Glider Service Bulletin

Date: February 19, 2024

Topic: Potential Oil Leak in the Forward Pump Section over time

Incorrect tubing (Left) is clear with silver spiral. Correct tubing (Right) is solid matte black.

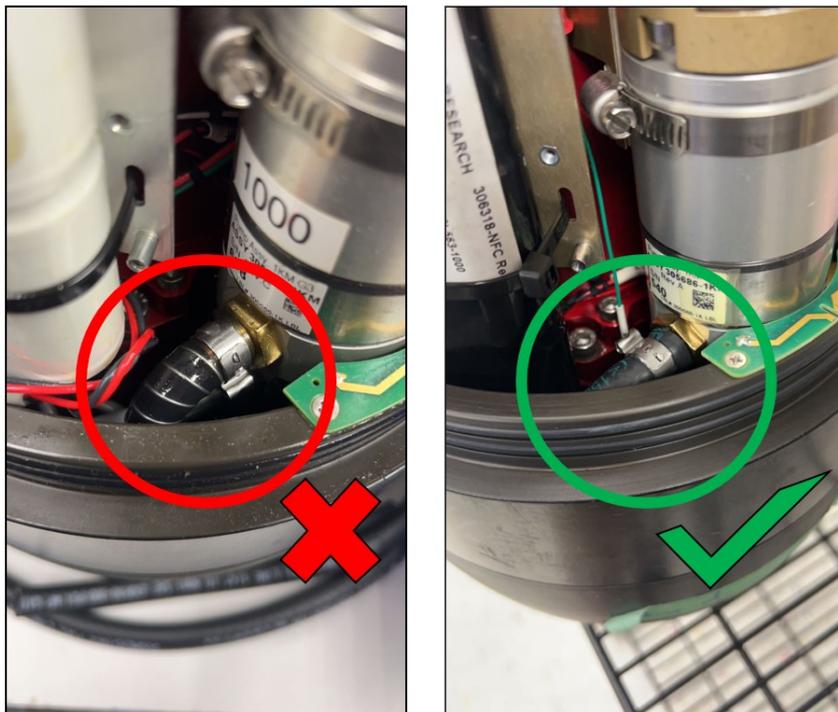
Teledyne Webb Research is notifying customers that G3 and G3s Deep Pump assemblies (1000m or 350m rated) belonging to gliders from serial number 627 through 1001 may have vacuum tubing installed that has a material incompatibility with the syndraulic oil used in the pumps. The incompatibility may cause the tubing to become brittle over time creating a leak potential. Shallow pump assemblies (200m, 100m, and 50m rated) are not affected by this issue.

To determine if your pump requires a tubing replacement, please refer to the figure below. The older, incompatible tubing is clear with a silver spiral wrapping around the outside. The newer, correct tubing is solid matte black.

If your unit has not had the tubing replaced during a routine or 1000M/20K PM Forward Pump Service conducted after April of 2022, your unit should be scheduled in for service. The tubing replacement will be conducted under warranty or concession at no cost for the service. If you are also due or overdue for a 20K Pump service, you can take advantage of this opportunity to have the service completed at the same time.
